CITY COUNCIL AGENDA ITEM COVER MEMO

Agreement with Wiregrass Construction Company, Inc.

Resolution authorizing the Mayor to enter into an agreement with the low bidder, Wiregrass Construction Company, Inc., for Downtown Gateway (Harvard Road Extension)-REBID, Option No. 2, Option No. 3, Option No. 4, Option No. 5, Option No. 7, Option No. 8 and Option No. 9, Project No. 65-11-RD03

OPTIONS PLAN SHEET

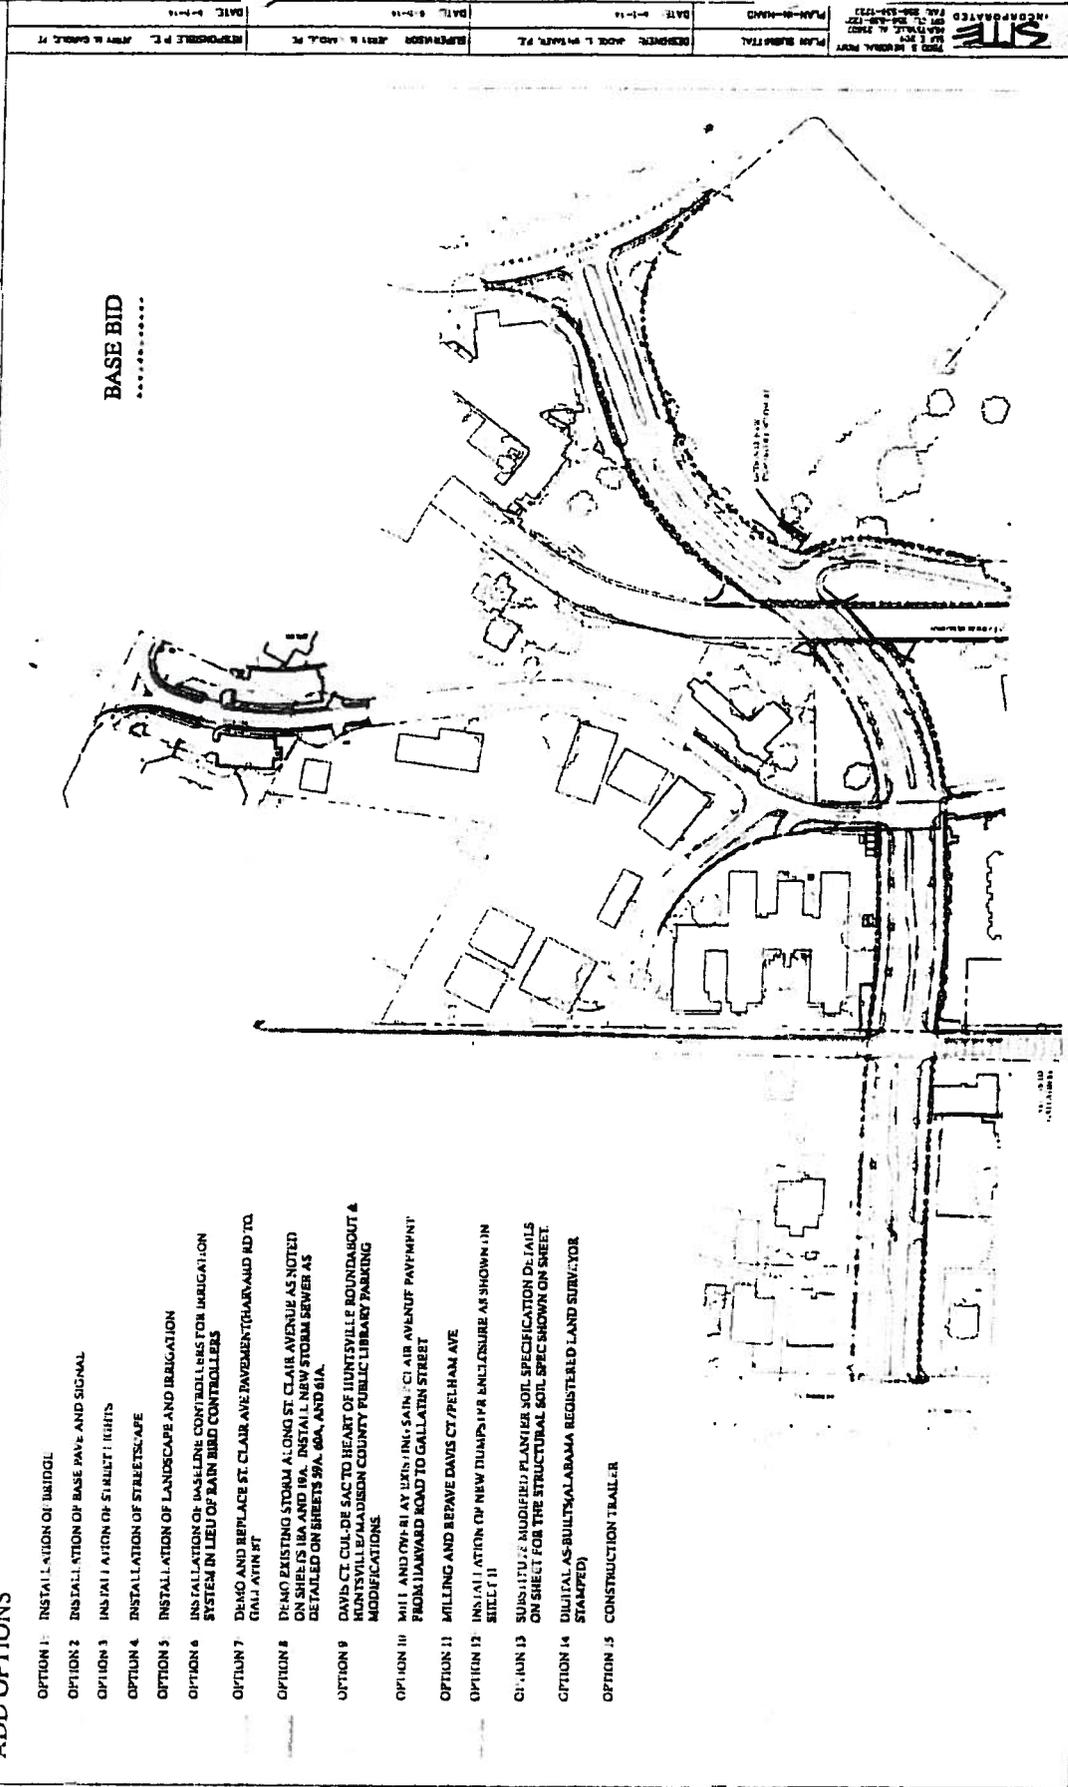
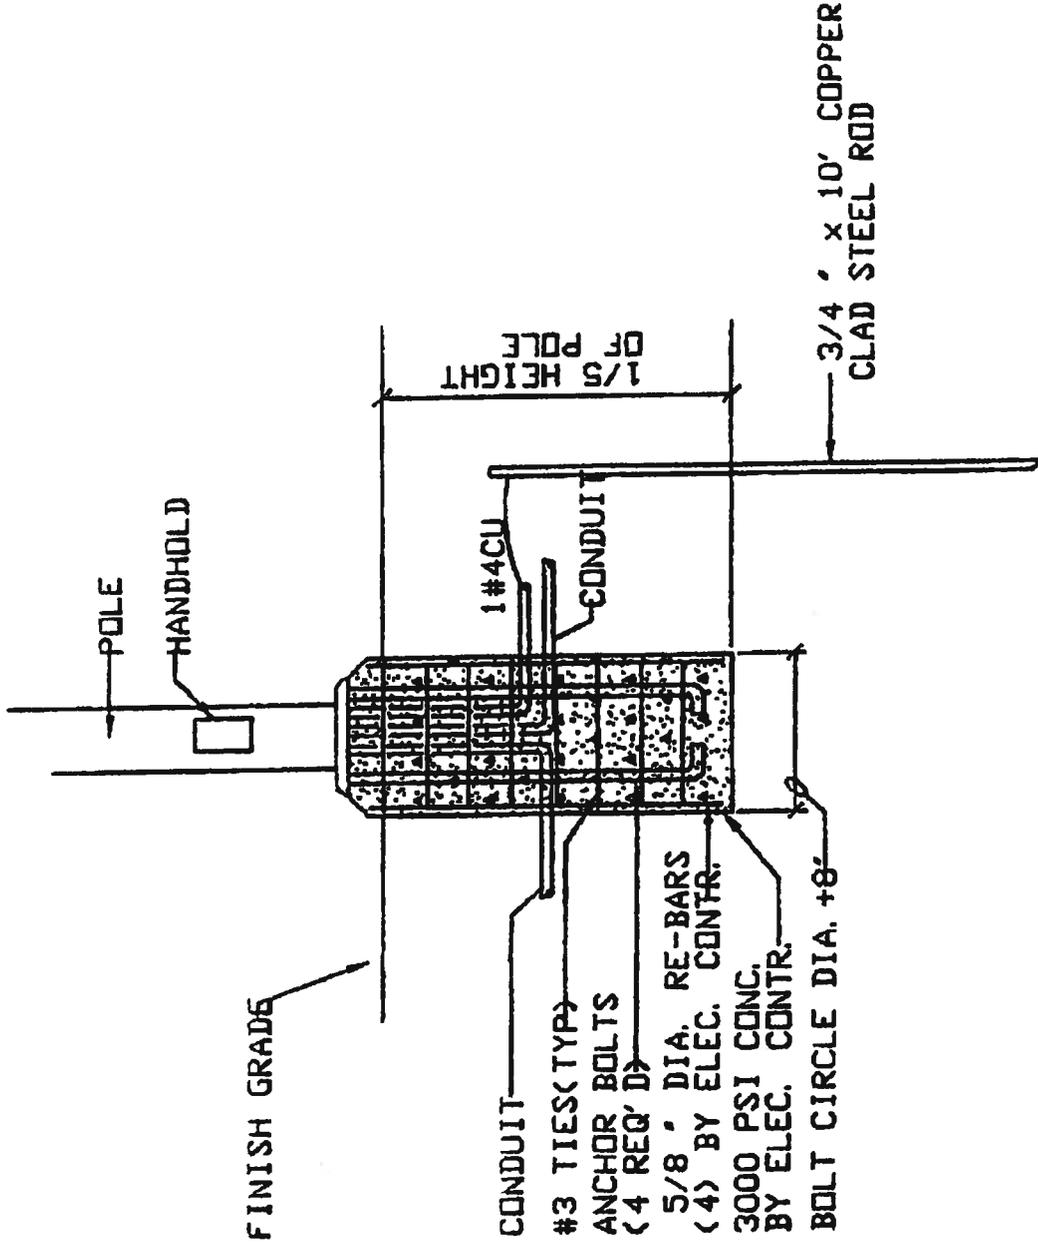
- OPTION 1: INSTALLATION OF SIGNAL
- OPTION 2: INSTALLATION OF BASE PAVE AND SIGNAL
- OPTION 3: INSTALLATION OF STREET LIGHTS
- OPTION 4: INSTALLATION OF STREETScape

- OPTION 5: INSTALLATION OF LANDSCAPE AND IRRIGATION
- OPTION 6: INSTALLATION OF BASELINE CONTROLLERS FOR IRRIGATION SYSTEM IN LIEU OF RAIN BIRD CONTROLLERS

- OPTION 7: DEMO AND REPLACE ST. CLAIR AVE PAVEMENT (HARVARD RD TO GALLATIN ST)
- OPTION 8: DEMO EXISTING STORM ALONG ST. CLAIR AVENUE AS NOTED ON SHEETS 10A AND 10B. INSTALL NEW STORM SEWER AS DETAILED ON SHEETS 9A, 60A, AND 61A.

- OPTION 11: MILLING AND REPAVE DAVIS CT/PELHAM AVE
- OPTION 12: INSTALLATION OF NEW DUMPS IFA ENCLOSURE AS SHOWN IN SHEET 11
- OPTION 13: SUBSTITUTE MUDFIELD PLANTER. SOIL SPECIFICATION DETAILS ON SHEET FOR THE STRUCTURAL SOIL SPEC SHOWN ON SHEET.
